Subject: 10 Jamieson Pde Collaroy NSW 2097 DA 2021/0006 WRITTEN
SUBMISSION: LETTER OF OBJECTION Submission: Tattersall

S U B M I S S I O N : T A T T E R S A L L
a written submission by way of objection to DA 2021/0006

Re:
10 Jamieson Pde Collaroy NSW 2097
DA 2021/0006

the demolition of the existing structures and construction of a new two storey dwelling with lower-level parking and a new swimming pool on Lot 14, Section 22 in DP 12012 which is known as No. 10 Jamieson Parade, Collaroy.

Non-Compliant Building Height & Wall Height. Registered Surveyors levels incorrectly shown

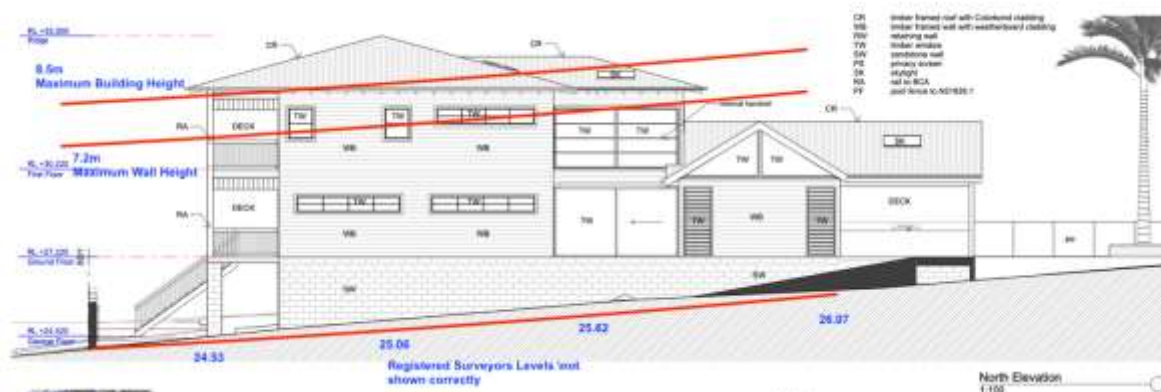
The Building Height is 10.1m. [18.3% non-compliance]

The proposed ridge is at RL 35.00, and that is positioned over the existing garage at RL 24.90 [survey]

The proposed development does not ensure that buildings are compatible with the height and scale of surrounding and nearby development.

There are no dwellings that are over 10m in height in the area. The non-compliant building height and coupled with the non-compliant wall height, side boundary envelope, and front setback only add to the lack of compatibility to surrounding and nearby development.

The proposed development does not minimise visual impact, disruption of views, loss of privacy and loss of solar access

The proposed development does not minimise any adverse impact of development on the scenic quality of Warringah's coastal and bush environments.

The proposed development does not manage the visual impact of development when viewed from public places such as parks and reserves, roads and community facilities.

Non-Compliant Front Setback

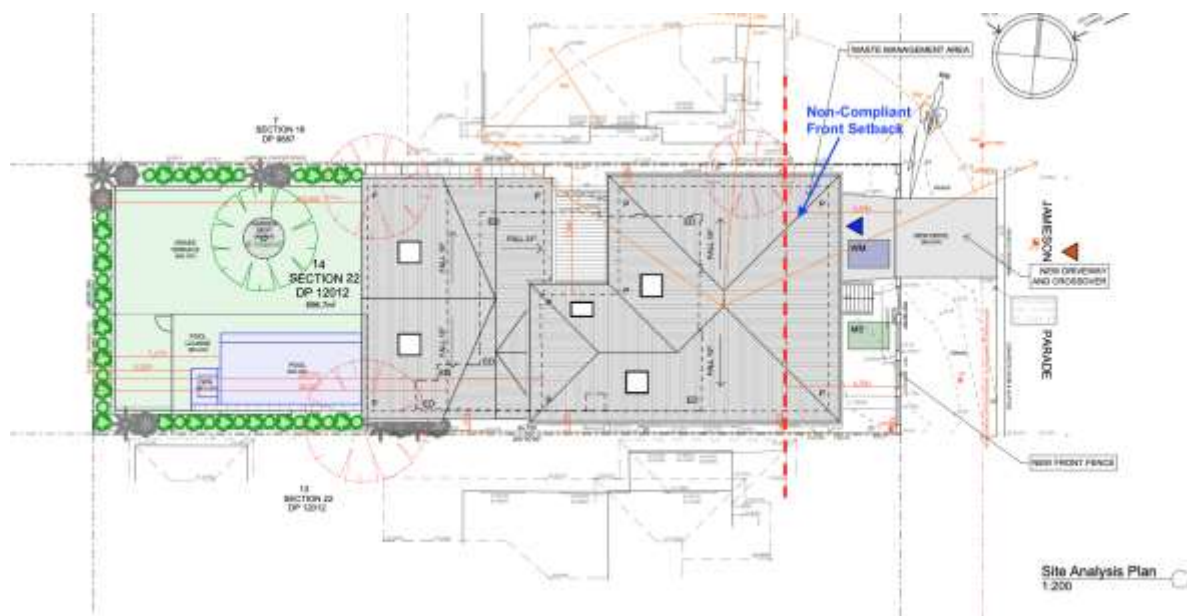
The front boundary is proposed at 4.05m, representing a 60.5% non-compliance.

Council will note that both neighbour's dwellings accord with the 6.5m control.

The proposed development does not create a sense of openness.

The proposed development does not maintain the visual continuity and pattern of buildings and landscape elements. Both neighbours are setback 6.5m for all wall zones and decks.

The proposed development does not protect and enhance the visual quality of streetscapes and public spaces.

Non-Compliant Side Boundary Envelope

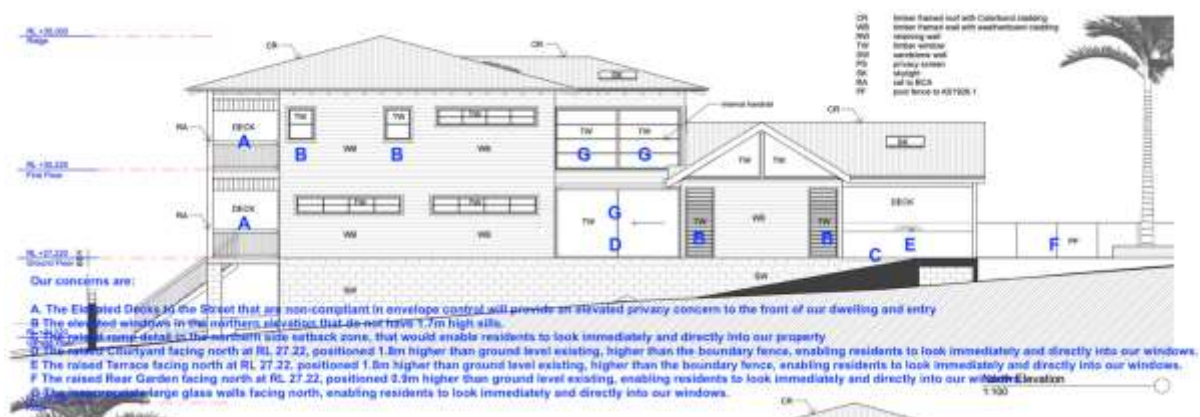
Grossly exceeds controls by 2.2m

The proposed development does not ensure that development does not become visually dominant by virtue of its height and bulk. The non-compliant side boundary envelope is fully expressed to the street frontage, presenting non-compliance by over 2.2m. The proposed development would become visually dominate, making the overall composition “*offensive, jarring or unsympathetic in a streetscape context, having regard to the built form characteristics of development within the site’s visual catchment*”

The proposed development does not ensure adequate light, solar access and privacy by providing spatial separation between buildings. Our privacy would be severely affected as windows in the upper levels would look directly into our dwelling and private open space. Daylight would also be greatly affected to the winter sky.

The proposed development does not ensure that development responds to the topography of the site. The proposed development does not step with the topography but simply presents non-complaint outcomes in every major control.

4. Reduce Envelope to fit within DCP B3 Side Boundary Envelope, from registered surveyor's levels as identified along northern boundary, particularly adjacent 6.5m front setback zone, RL 24.53, 25.06, 25.62, 26.07, and 26.78. Prepare 3D model to clearly show full compliance. Minimum 3m side setback to upper floor. [Reason: Streetscape, Visual Bulk, Bulk & Scale, Privacy]
